Technical Service Bulletin: tsb100125

Gear Cover Bushing Installation Instructions

This Technical Service Bulletin introduces the new front support trunnion for the QSK45 and QSK60 Series engines. This Technical Service Bulletin also revises Procedure 001-031, Front Gear Cover, for the Troubleshooting and Repair Manual, QSK45 and QSK60 Series Engines, Bulletin 3666217. The new trunnion, Part Number 4066304, is cast-steel design and was first used in production on engine serial number first 33148569.

Fig. 1, Front Support Trunnion with New Grease Fitting Location (1)

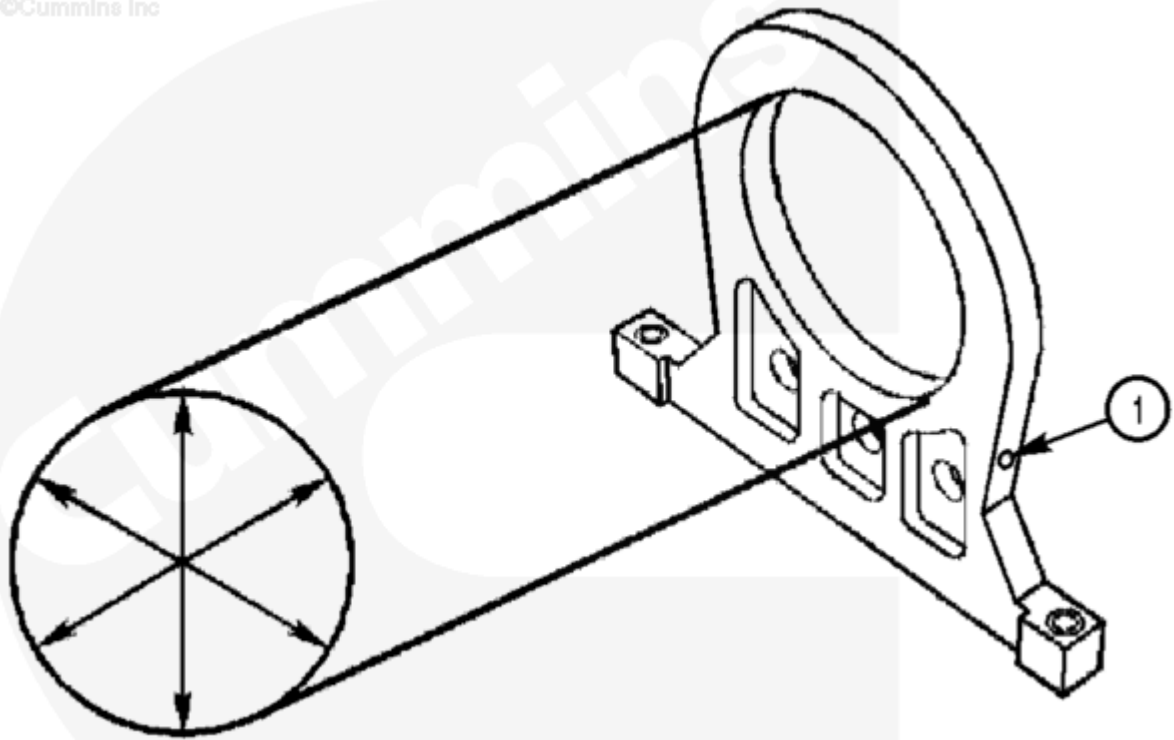
The grease fitting (1) has been moved to the lower left-bank side of the trunnion.
